# **TEMPORARY DRAINAGE PROPOSAL (Final)**

APPLICATION SITE OF THE PROPOSED  
TEMPORARY LOGISTICS CENTRE FOR A PERIOD  
OF 3 YEARS FOR A PERIOD OF 3 YEARS LOT 598  
S.C (PART) IN D.D. 114 AND ADJOINING  
GOVERNMENT LAND, SHEK KONG, YUEN LONG,  
NEW TERRITORIES

**PROJECT NO. AGLA/TDM/009**

**Response to Comments on Temporary Drainage Proposal (Issue 2)**

**APPENDIX G**  
**SECTION**

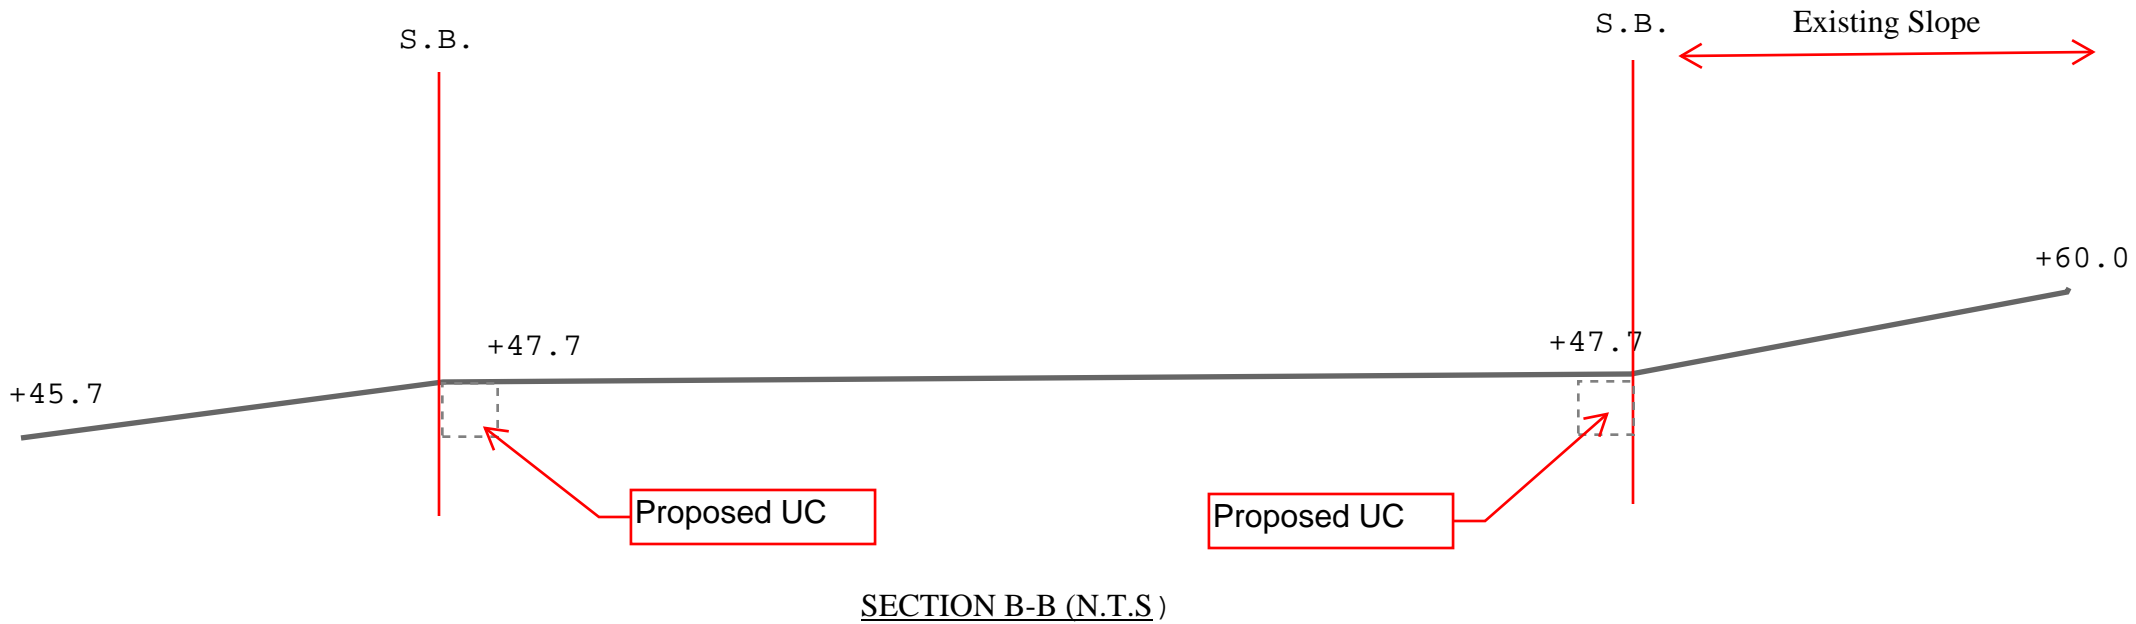
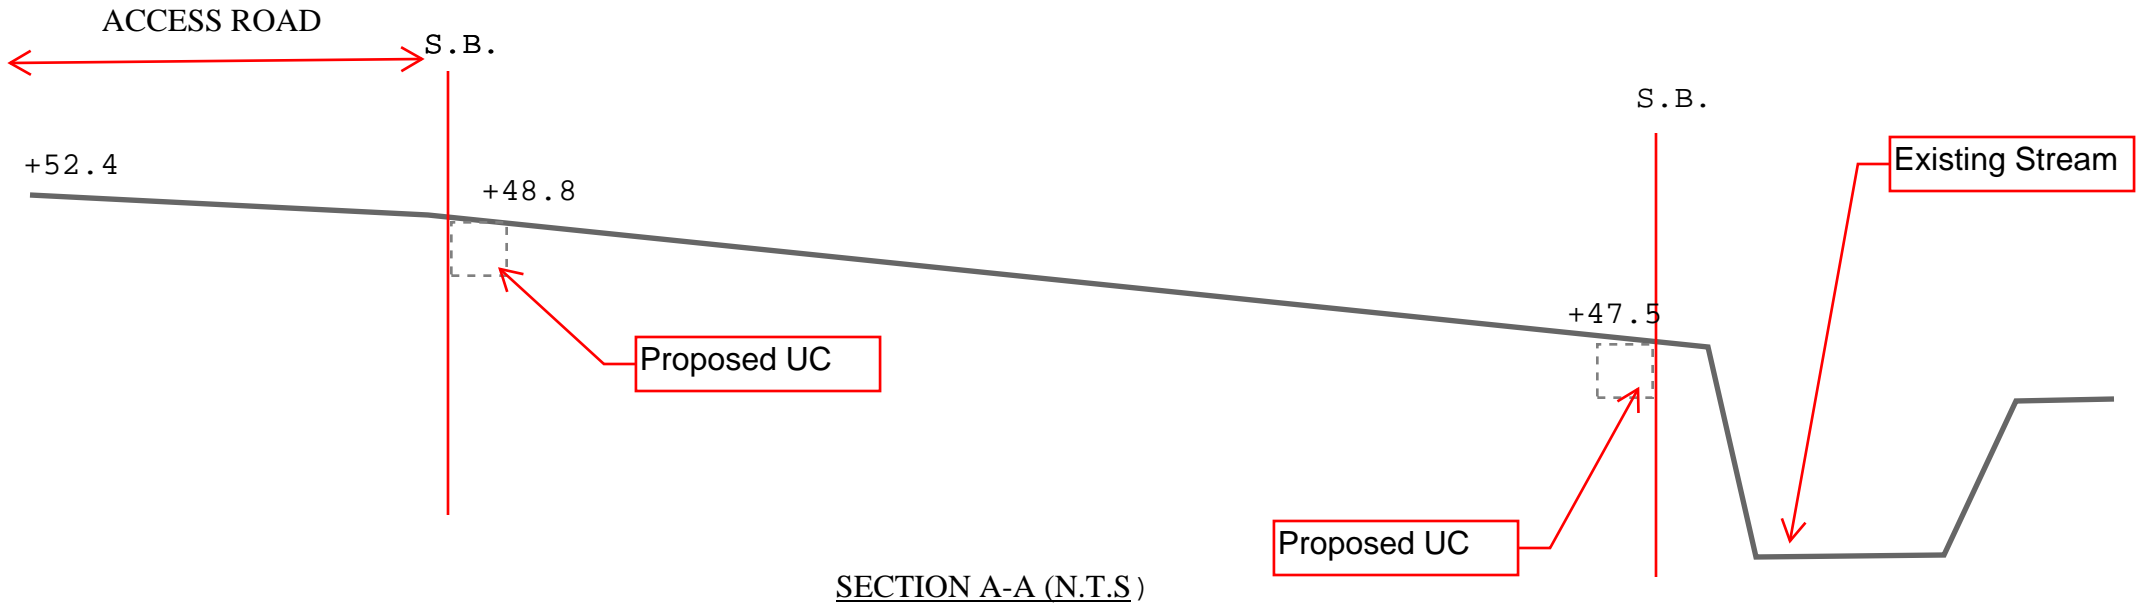
(iii) Further to (ii) above, since there is no record of the said discharge path, please provide site photos to demonstrate its presence and existing condition; and	Site Photos are provided in Appendix H
(iv) Cross sections showing the existing and proposed ground levels of the captioned site with respect to the adjacent areas should be given	Cross sections are provided in Appendix G
